**Amendments to the drawings:**

Replacement  
Sheet

Fig.1

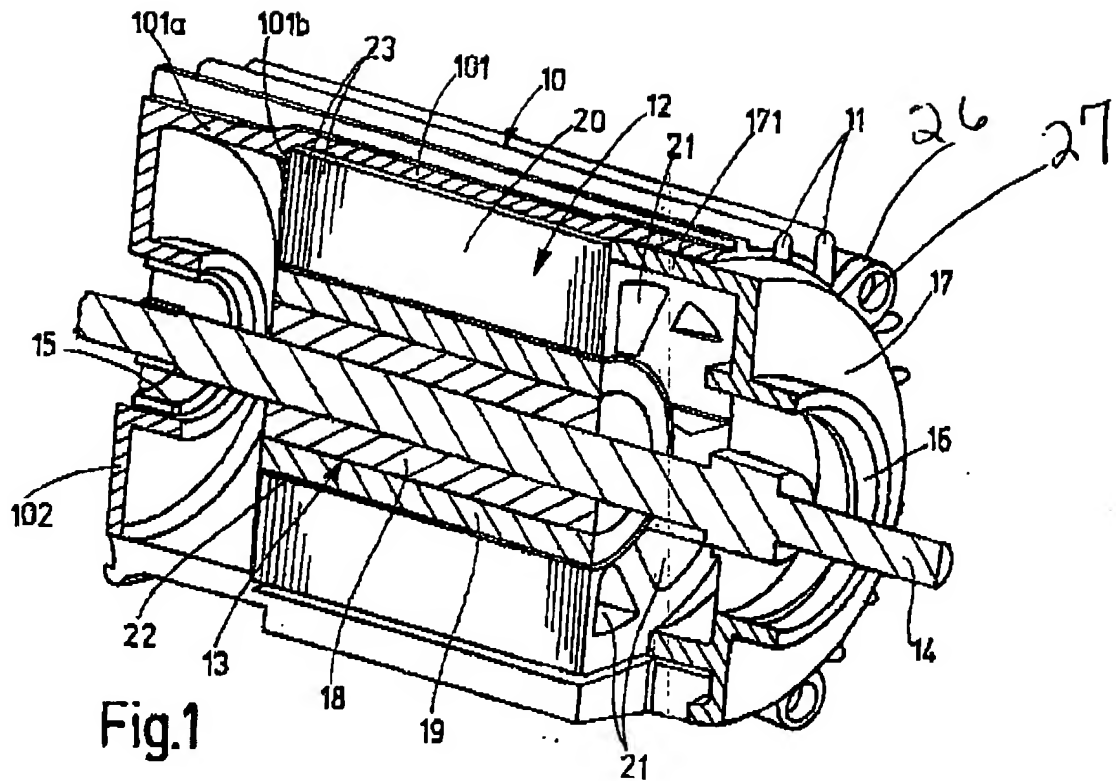
Attached is one replacement sheet, in which Figure 1 has been amended to indicate the lugs 26 and throughgoing openings 27 as described in the specification.
